**Proposal #16: 2656-00-72**  
**C Milwaukee S 70<sup>th</sup> Street**  
**Bridge over CP RR/HAST P-40-856**  
**Loc Str**  
**Milwaukee County**

This is Addendum No. 01, which provides for the following:

**ADDENDUM NO. 01**

**2656-00-72**

Addendum No. 01  
 ID 2656-00-72  
 Revised Sheet 14  
 March 8, 2023

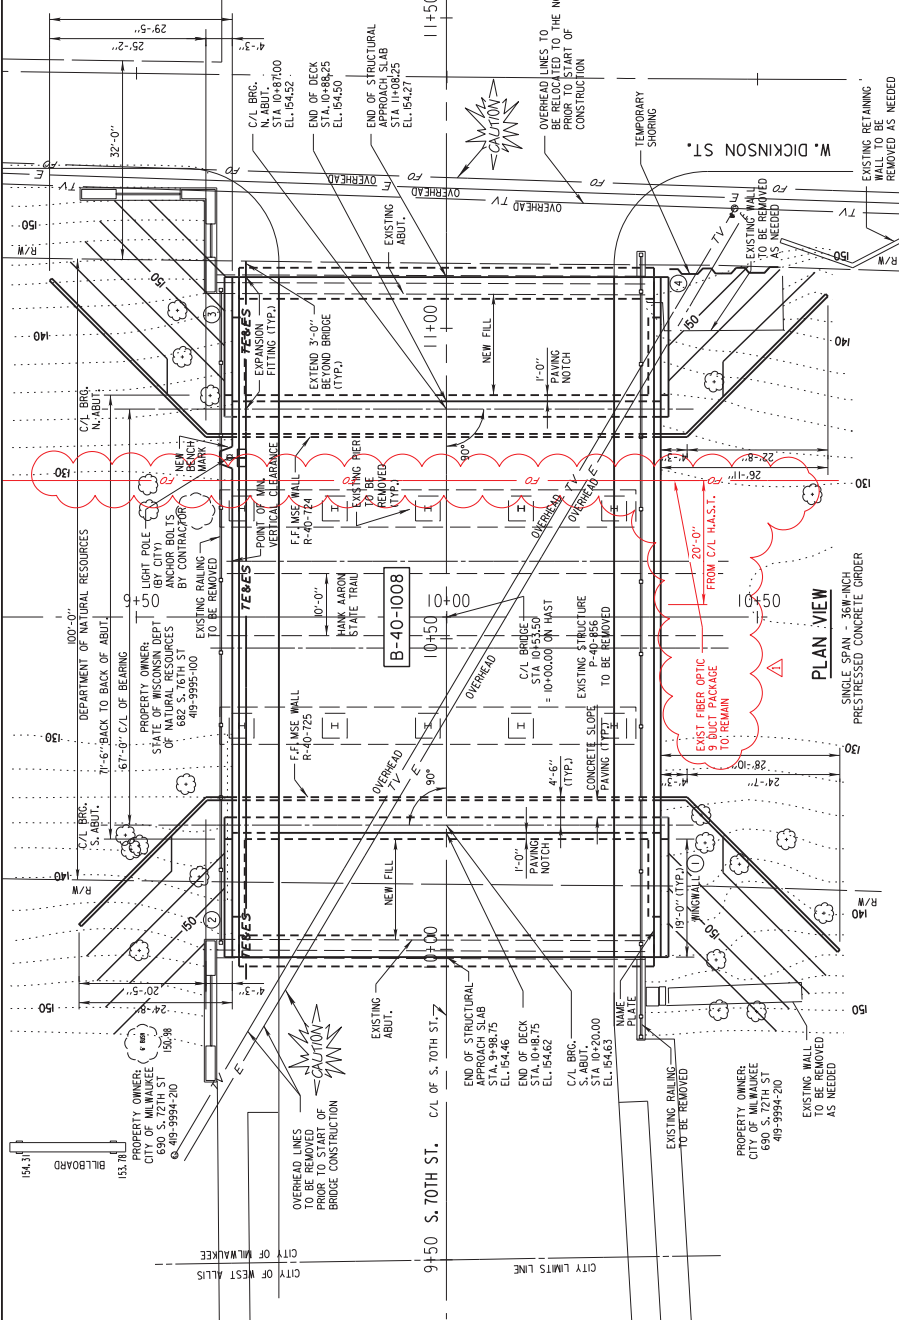
<b>Revised Plan Sheets</b>	
<b>Plan Sheet</b>	<b>Plan Sheet Title (brief description of changes to sheet)</b>
14	AT&T underground Transmission line added
35	Miscellaneous Quantities; Added AT&T Fiber Optic Protection
117	Added AT&T underground Transmission line. Footing removal depth revised from 4'-0" to 2'-0"

SITE PLAN AND ELEVATION SHEET 117 OF 25

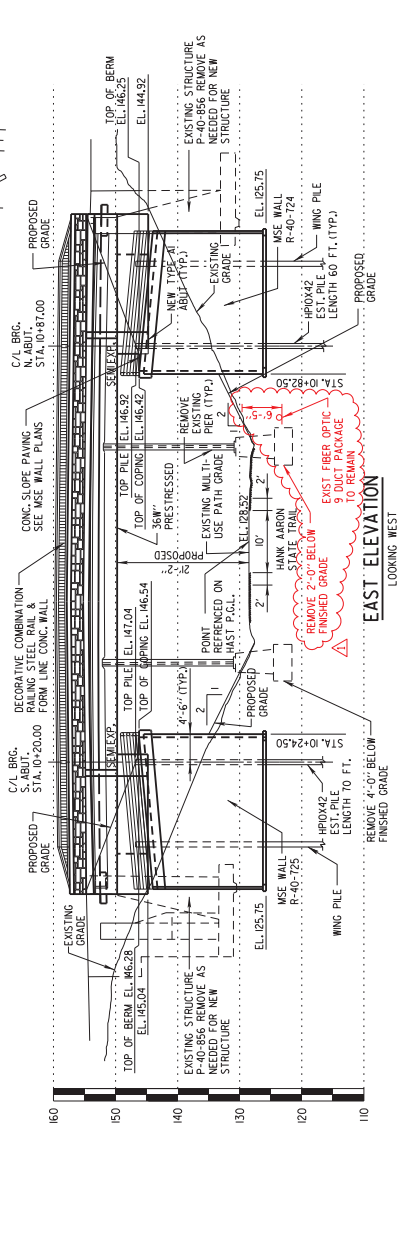
NO.	DATE	REVISION	S.S.R.	BY
1	3/2/23	ADD #1 - EXISTING AT&T CORP.
